SLIM CHICKENS SITE PLAN

TOWN OF PARKER PLAN REVIEW

SITE PLAN
SLIM CHICKENS
COVER SHEET
SVC OF S. PARKER ROAD AND E. PINE LANE, PARKER, CO 80134

1 NORTH ELEVATION
SCALE: 1/4" = 1'-0"
East facing Parker Road
Label updated

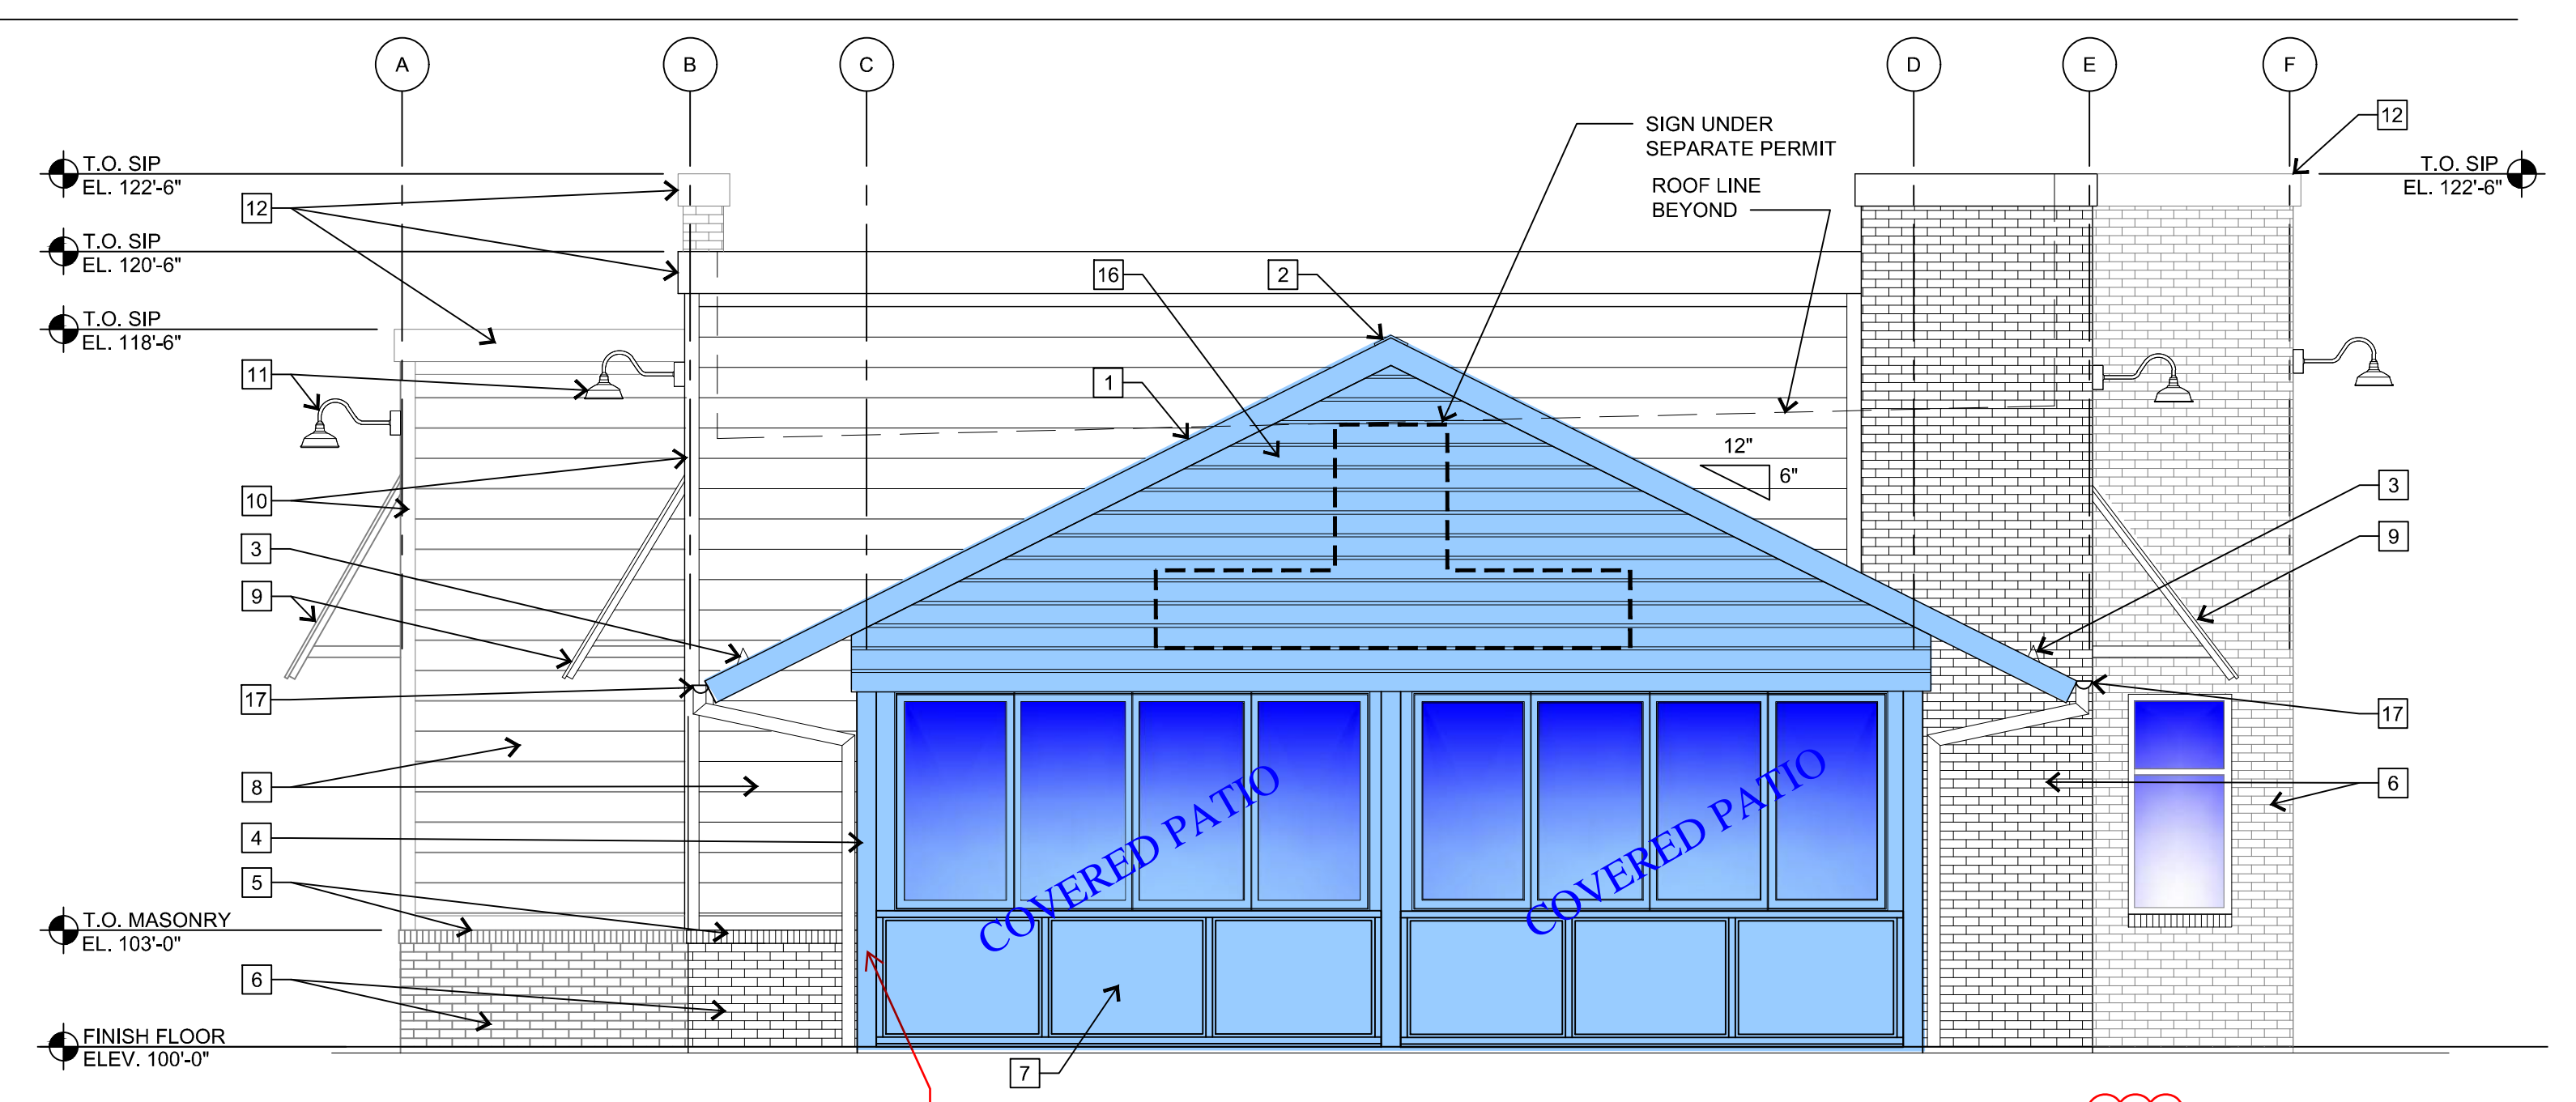
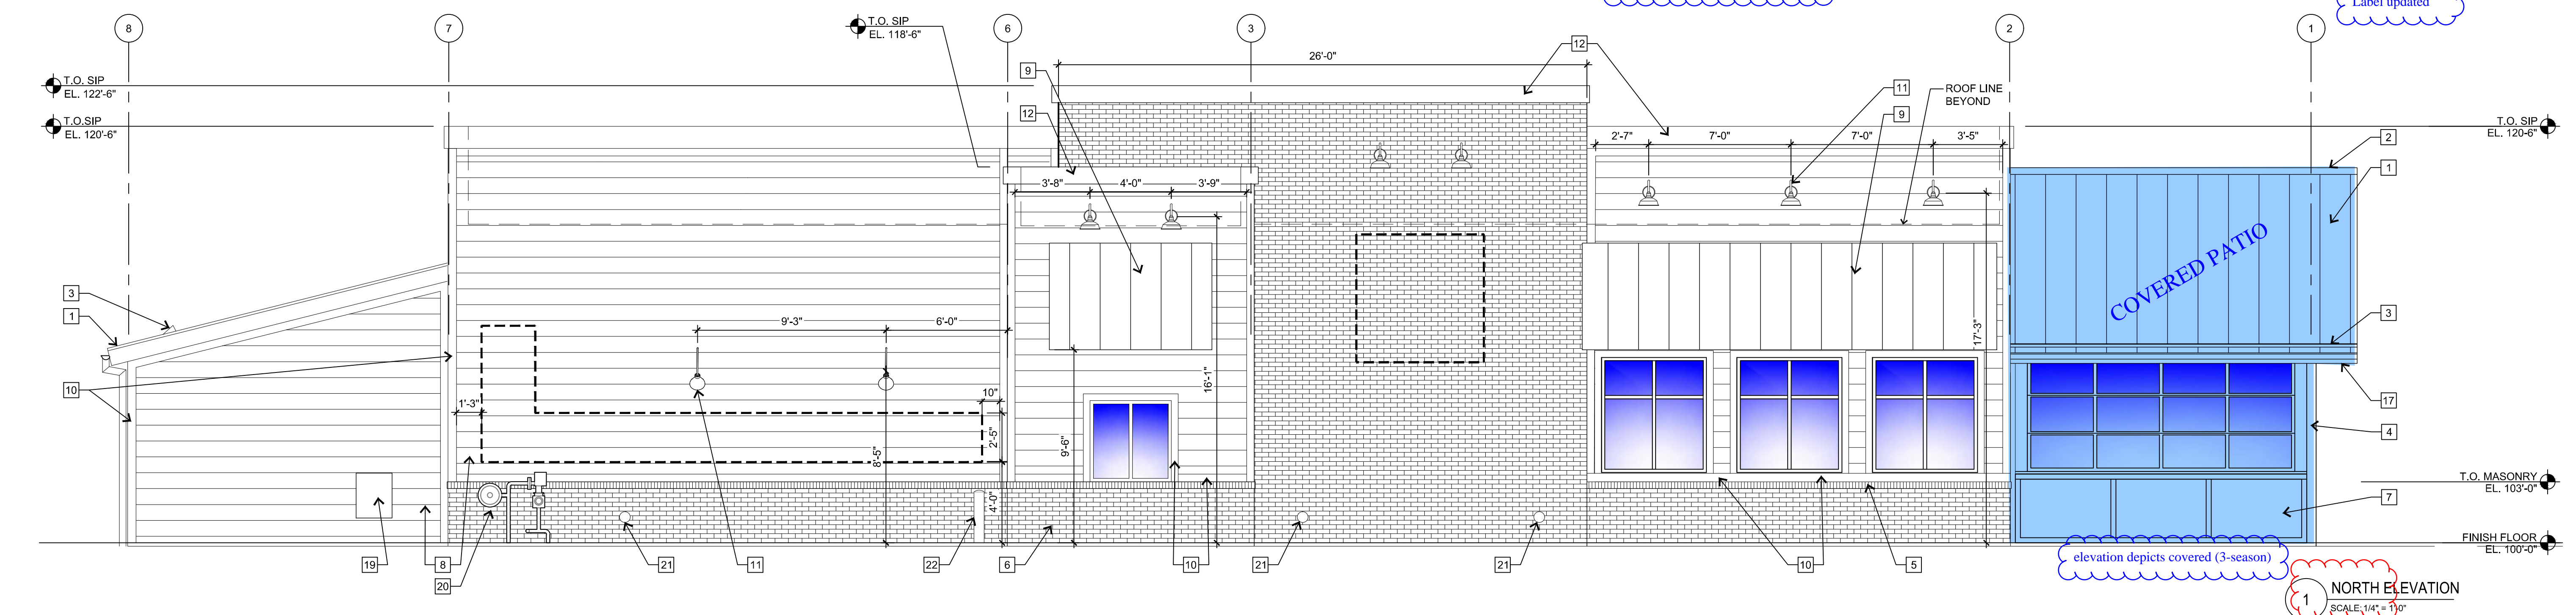
Covered patio interior elevation - containing for review

Please show fenced patio area & gate as depicted on site plan
elevation depicts covered (3-season)

2 WEST ELEVATION
SCALE: 1/4" = 1'-0"
North
Label updated

SITE LIGHTING PLAN
PROJECT NO: TSD003.01
DESIGNED BY: CAM
DRAWN BY: CAM
DATE: 06/15/2020
P5.0
SHEET 8 OF 9

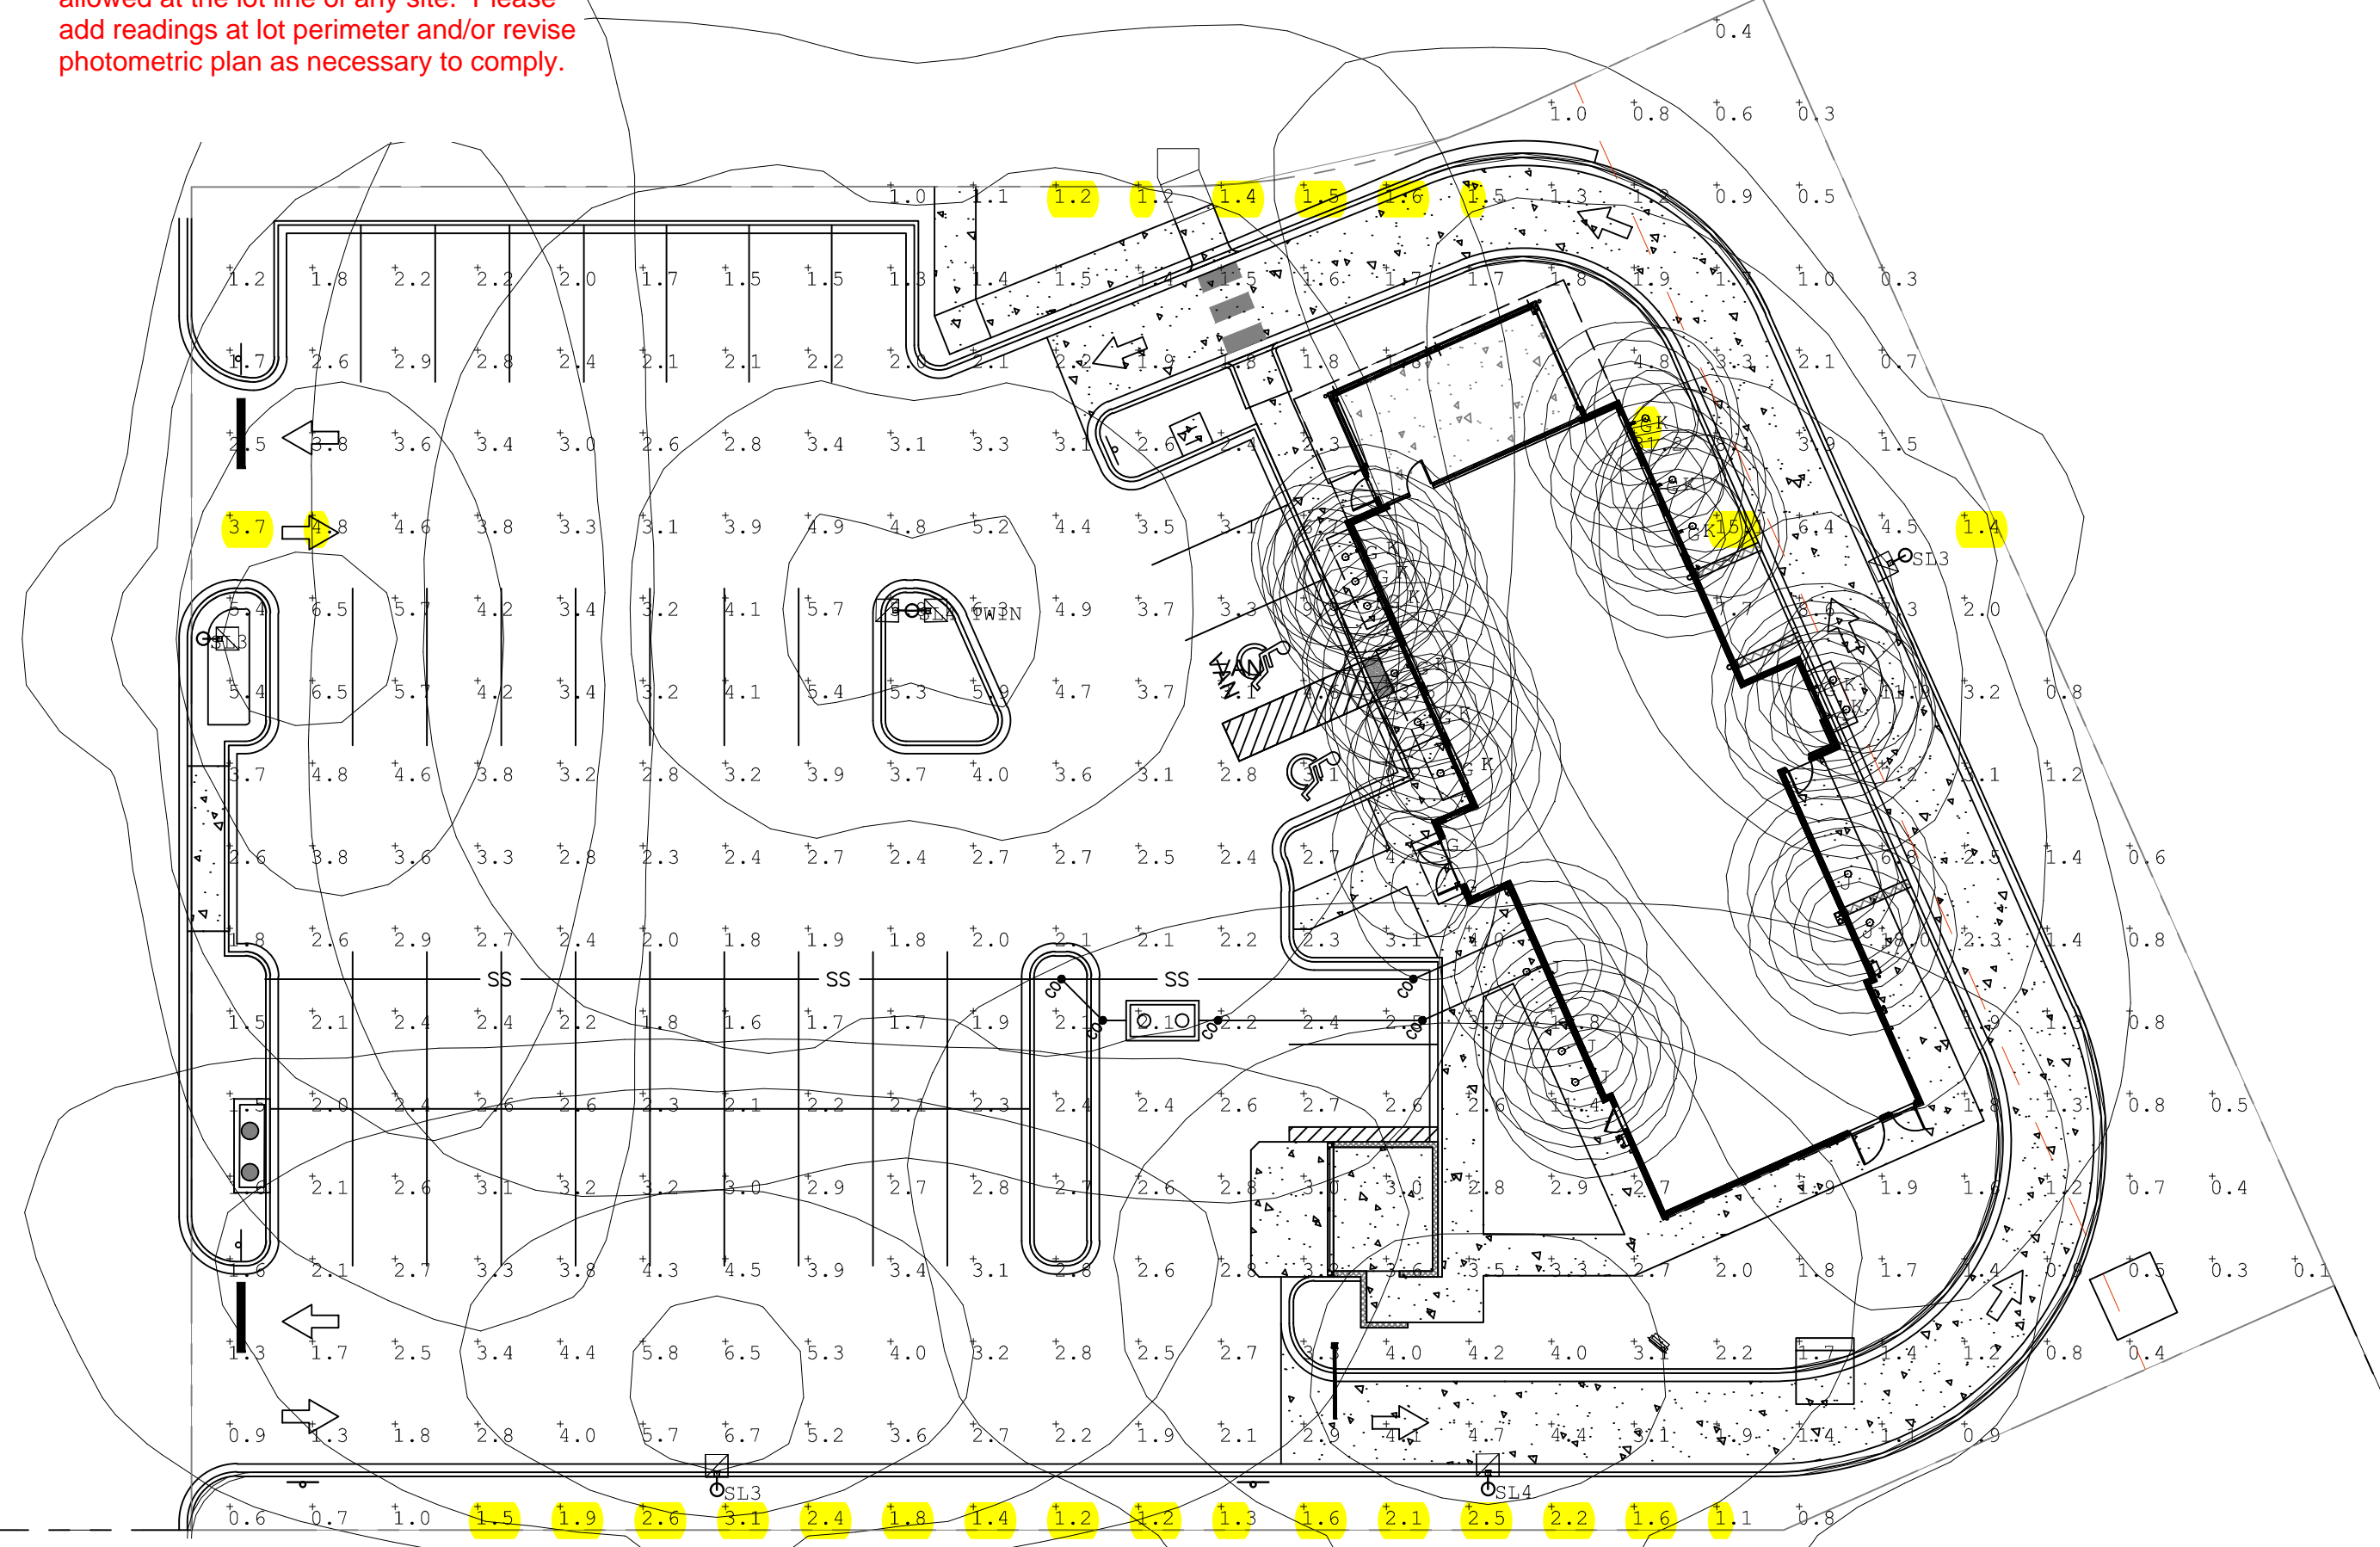
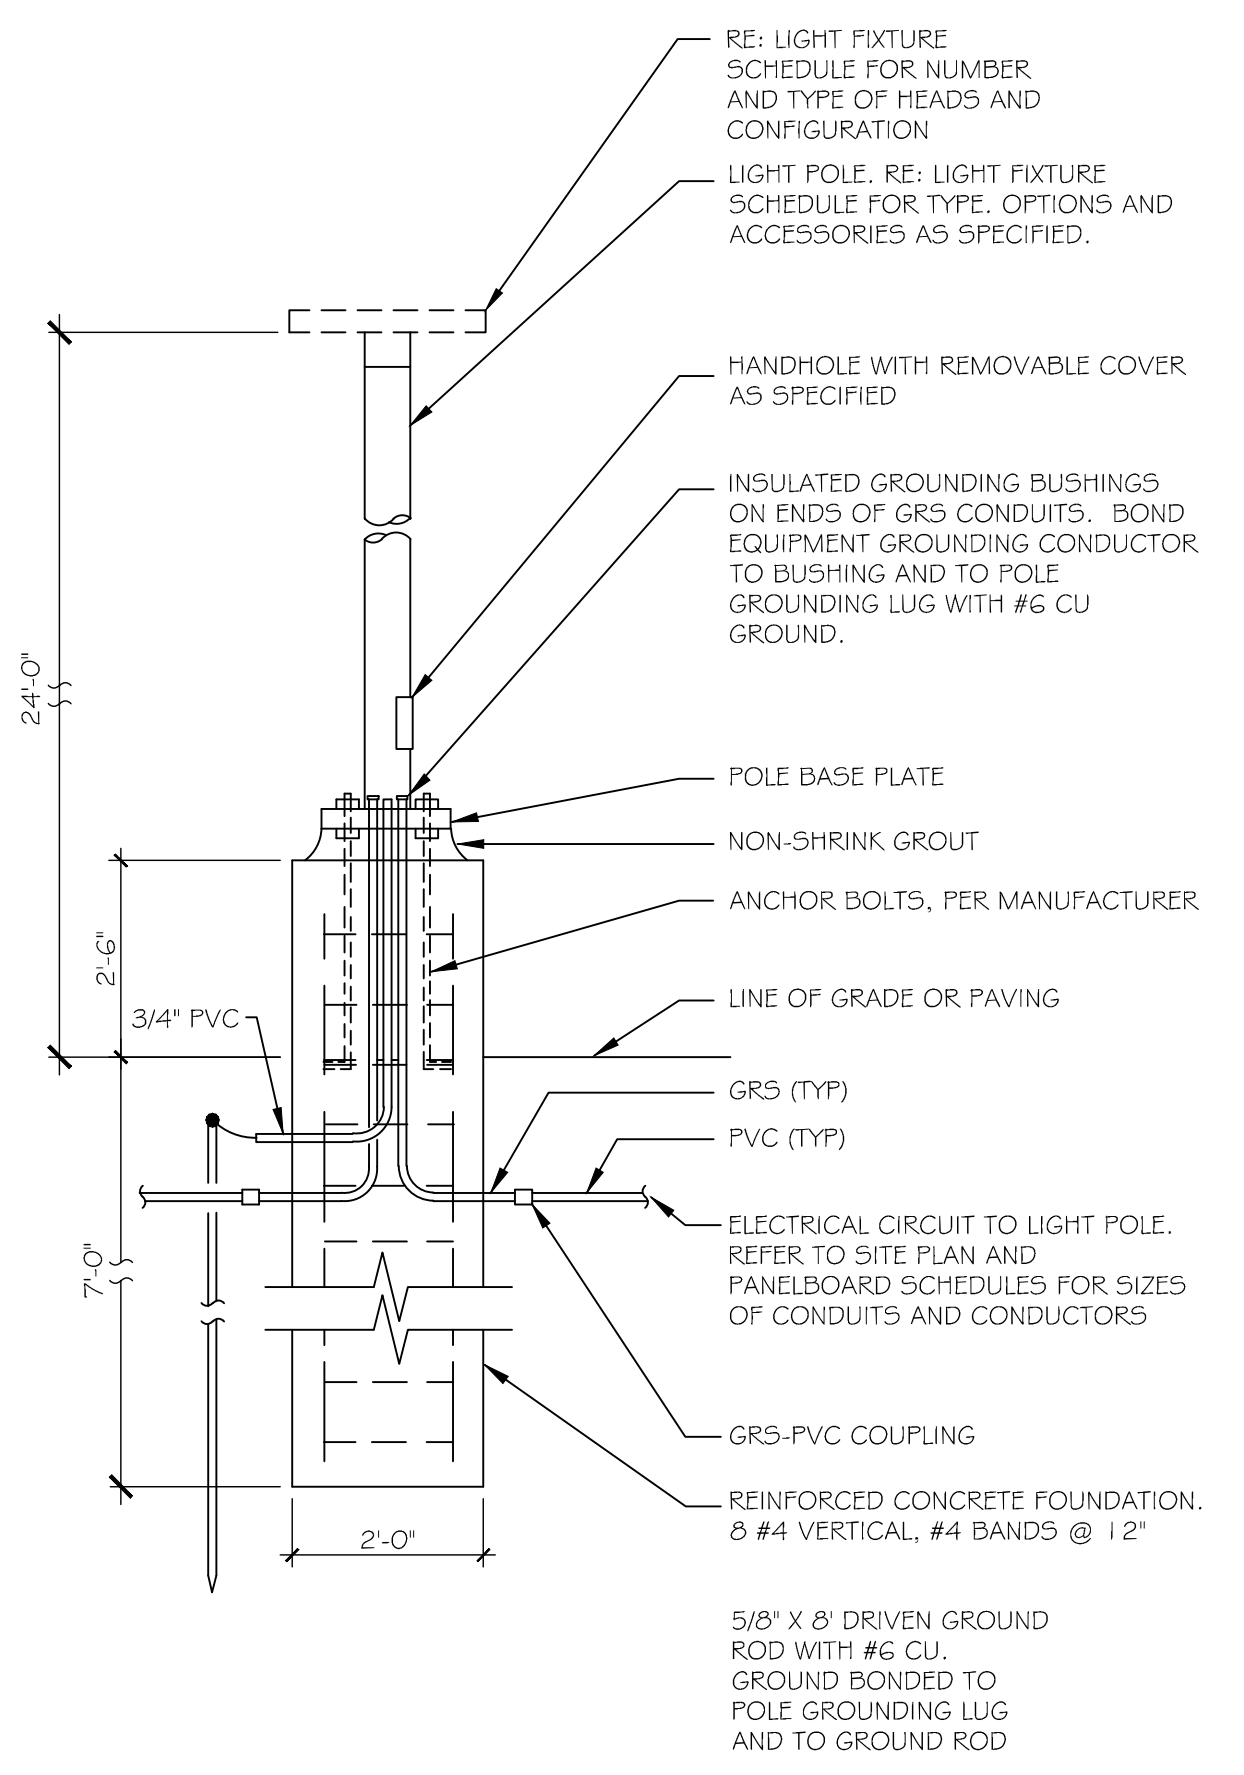
Please identify which type light(s) are proposed and state lumens. Max foot candle is 12,000 (installed illuminance). Please confirm compliance

Overlap - please fix.

See also 13.10.140(e)(4) for floodlight standards and confirm compliance. Max intensity is 35,000 lumens
